Bid Bulletin #02

PROJECT: Educare of Winnebago
Bid Package #04
Winnebago, NE

ADDENDUM G

Educare Winnebago
Winnebago, Nebraska
RDG Project No. 2010.175.00, File 35.1

2010.175.01
 SDS-018

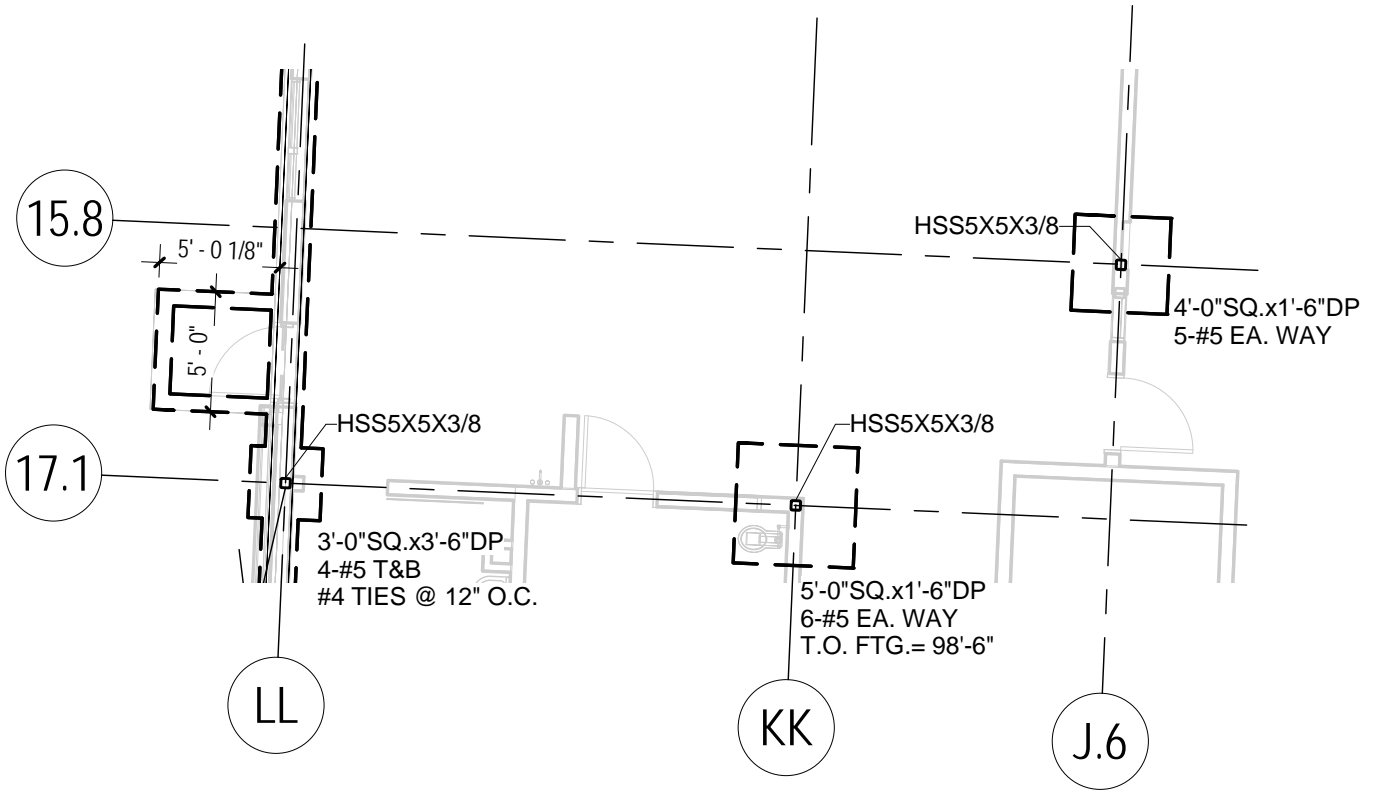
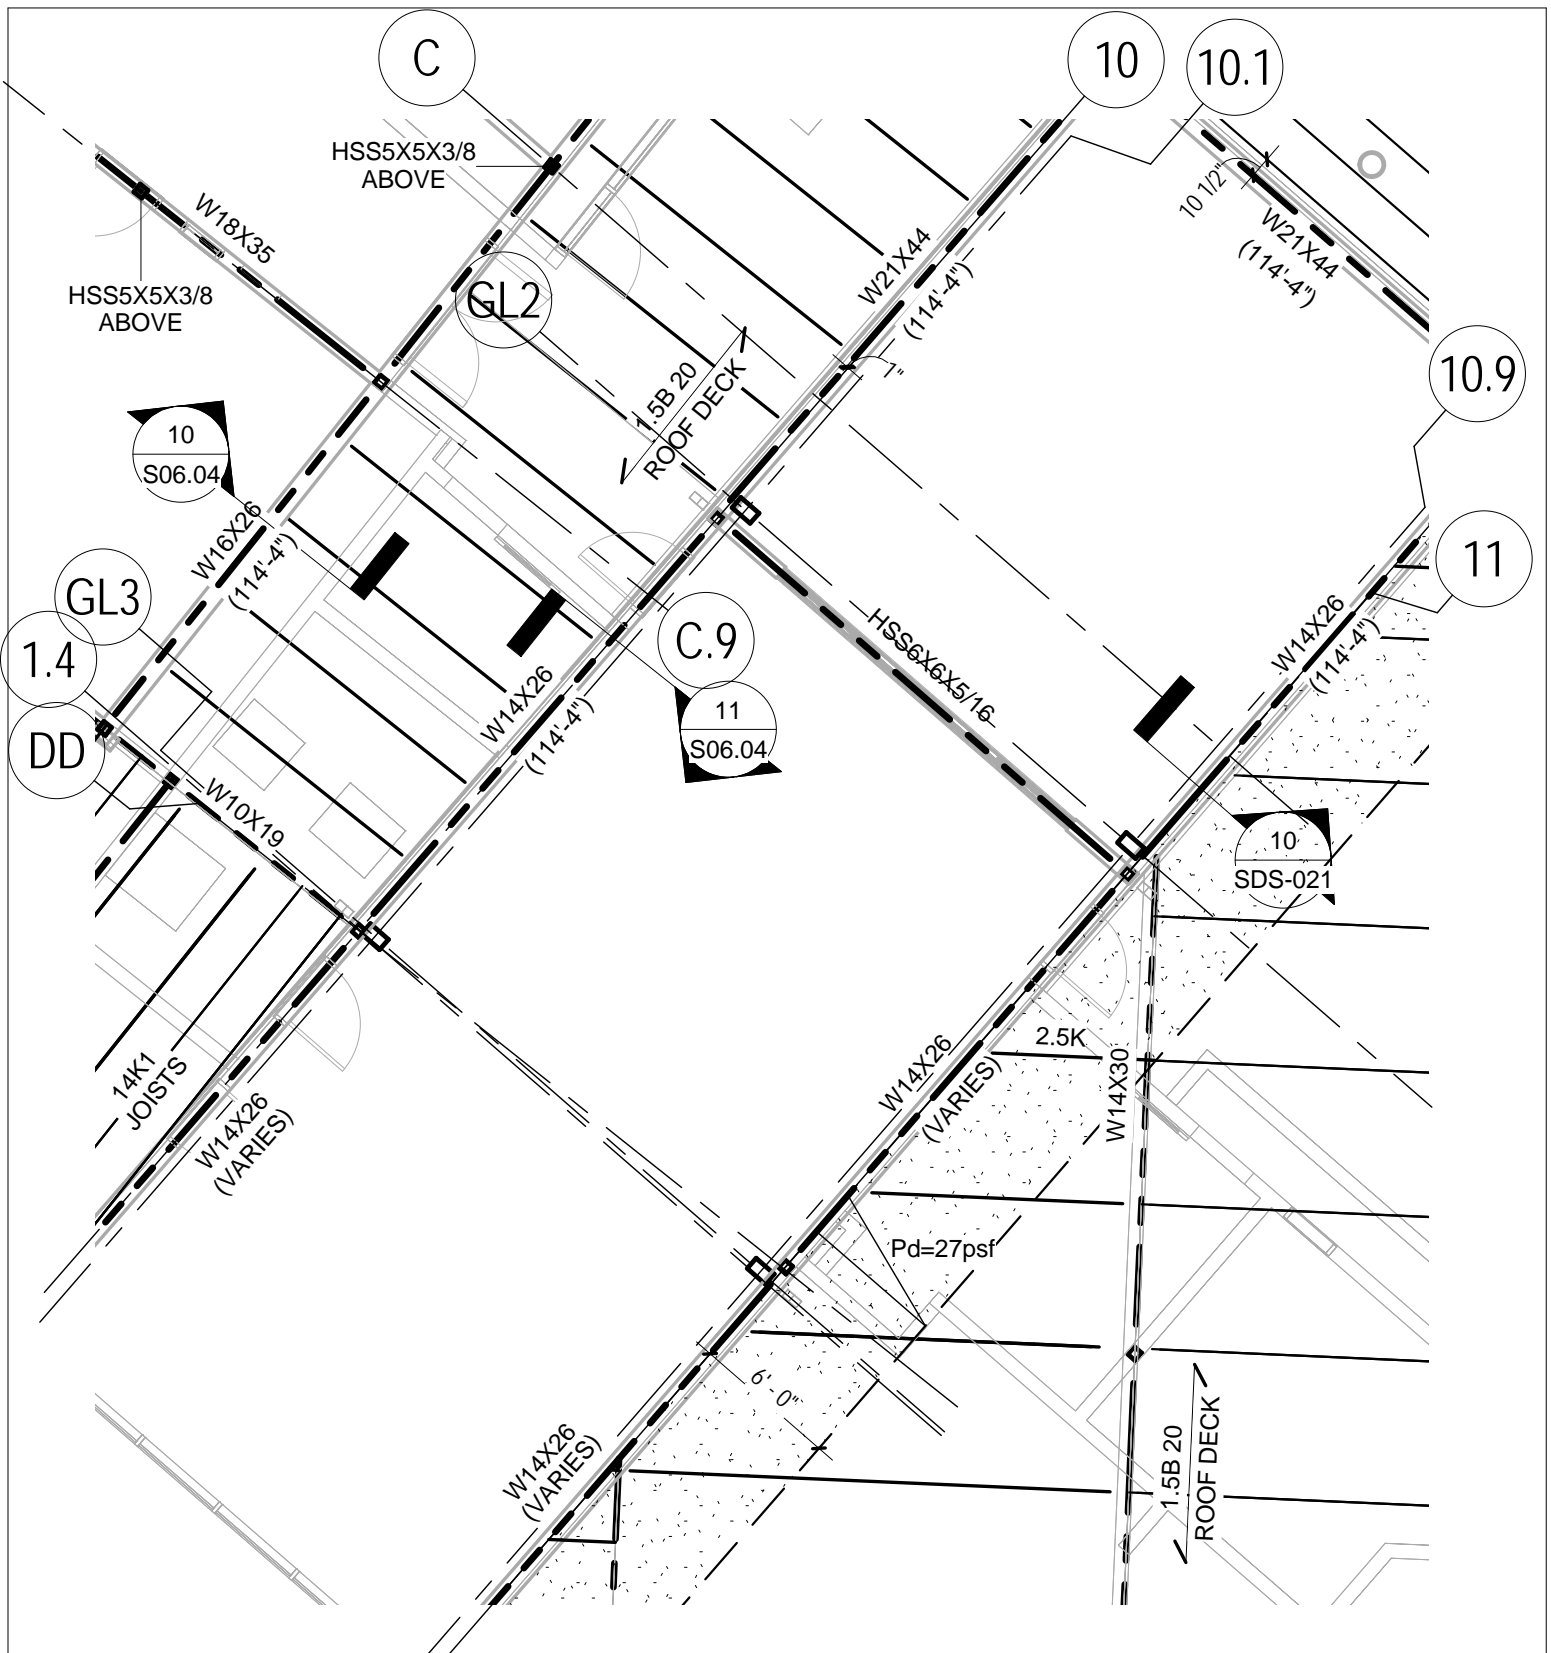
- A. Column at Grid J/23.5 shall be noted as "***HSS5X5X3/8.***" See enclosed Structural Sketch SDS.018.
- B. Column shown near Grid J, 15.8 shall be located on grid. See enclosed Structural Sketch SDS.018.

DATE: 12/14/12
 MODIFICATION:
 REF'D SHEET: S02.01
 REF'D DETAIL:

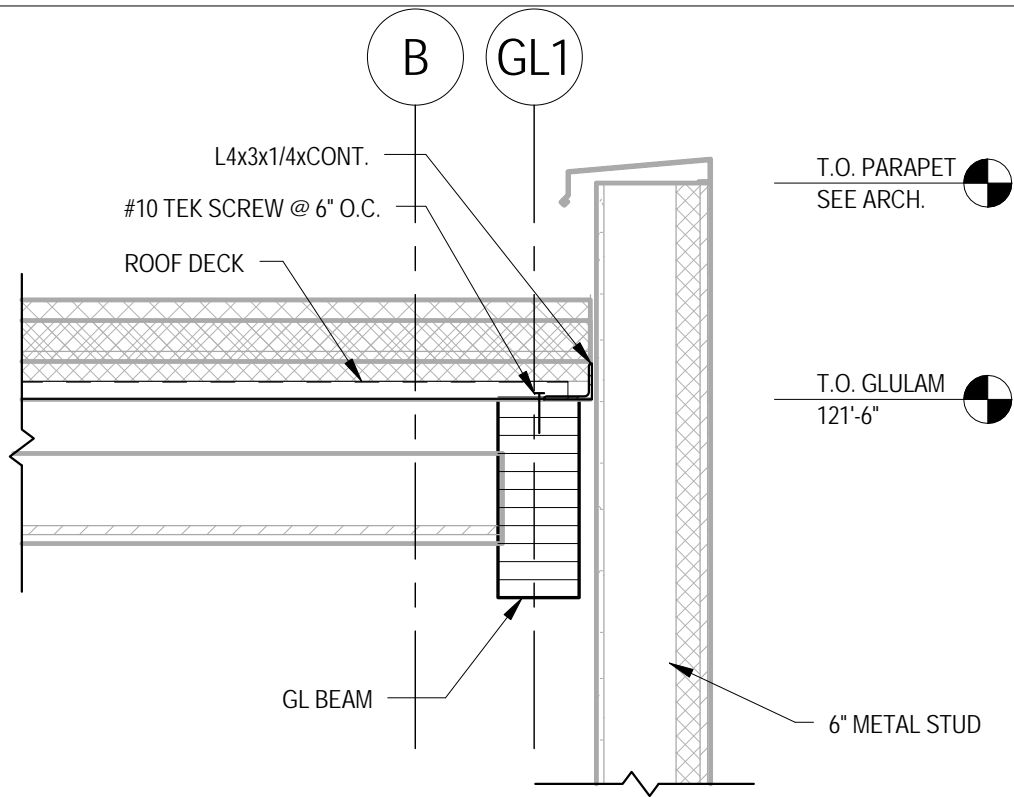
GSD-2 Sheet S2.01: See enclosed Structural Sketch SDS.020.

- A. Revise framing sizes at Grids 10, 11 as shown.
- B. Move W21x44 off Grid 10 by 1".

DATE 12/14/12
MODIFICATION:
REF'D SHEET: S06.05
REF'D DETAIL: 9 & 10

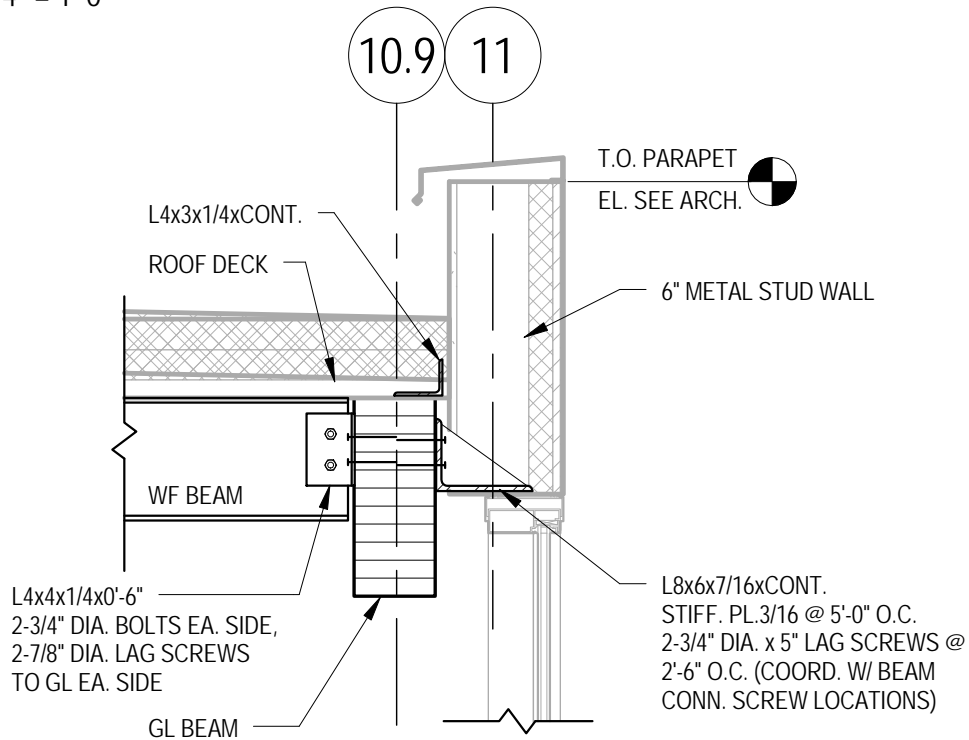
GSD-5 Sheet S6.05, Detail 9: Change angle size to "***L4x3x1/4xcont.***" See enclosed Structural Sketch SDS.021.

- A. Change angle size to "***L4x3x1/4xcont.***"
- B. Change bracket size to "***L8x6x7/16xcont.***"

DRAWING REFERENCED: P01.01
ADDENDUM NO.: G

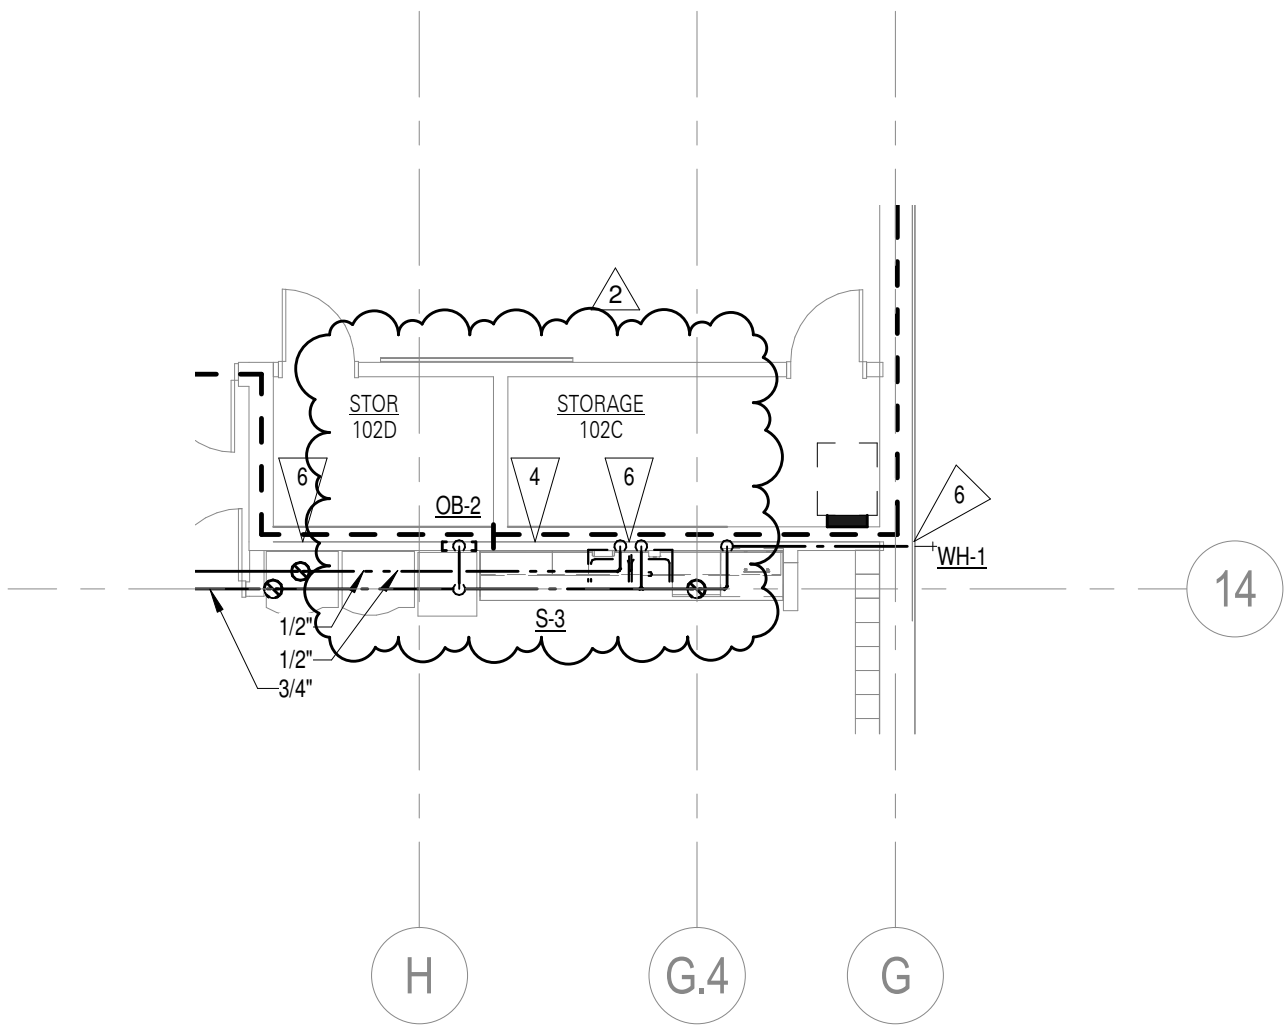
GMD-1 Sheet P01.01 – Below Grade Plumbing Plan – North: Revise sheet as indicated on attached Mechanical Sketch MS-3.

PROJECT NO. 20122634	DATE 12/13/12	DRAWING REFERENCED: E02.01 ADDENDUM NO.: G	SKETCH ES-4
-------------------------	------------------	---	----------------

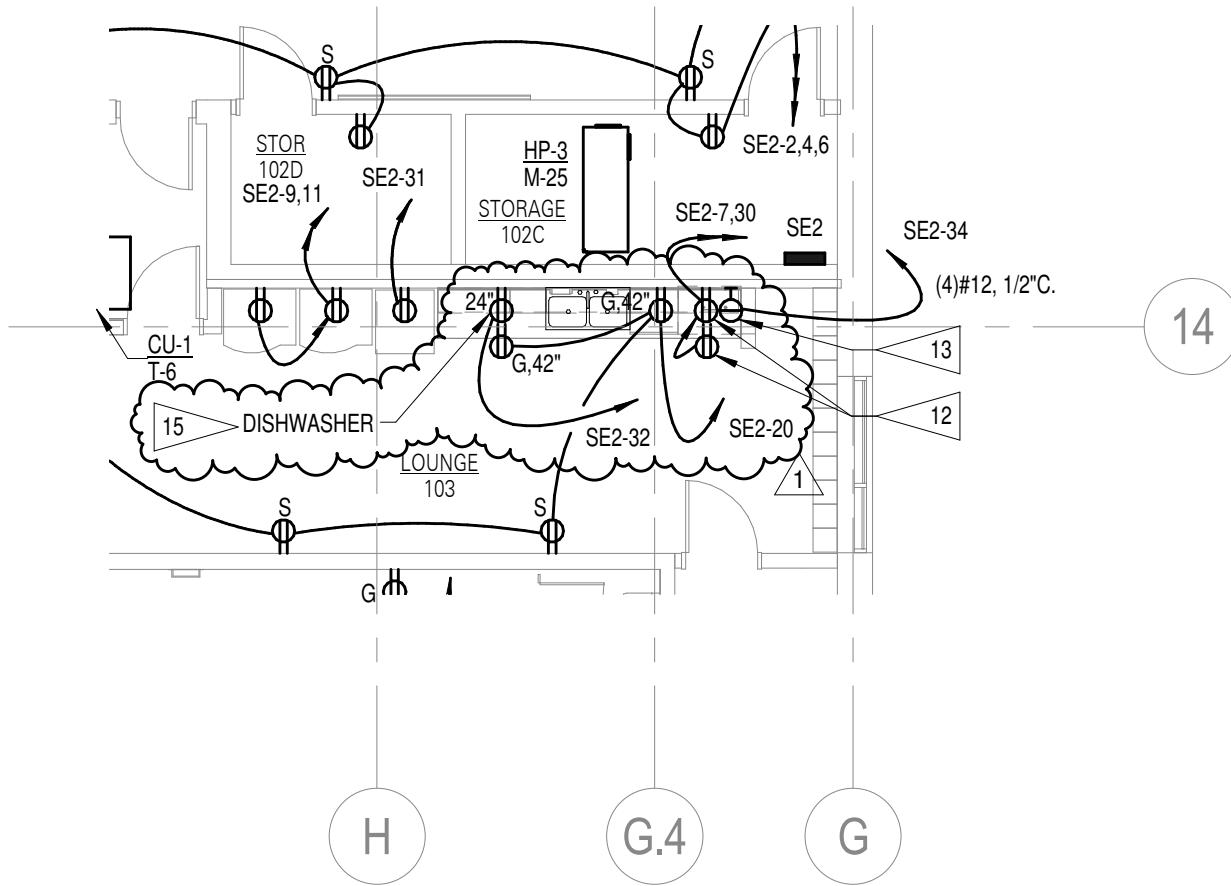
- A. Lounge 103: Relocate dishwasher receptacle and add Flag Note 15 per attached Electrical Sketch ES-4.
- B. Revise Flag Note 13 to read as follows:

- 13. PROVIDE PLUG AND CORD CONNECTION FOR UNDERCOUNTER OVEN. COORDINATE RECEPTACLE CONFIGURATION WITH EQUIPMENT MANUFACTURER. VERIFY ACCESSIBLE RECEPTACLE LOCATION WITH CASEWORK DETAILS.**
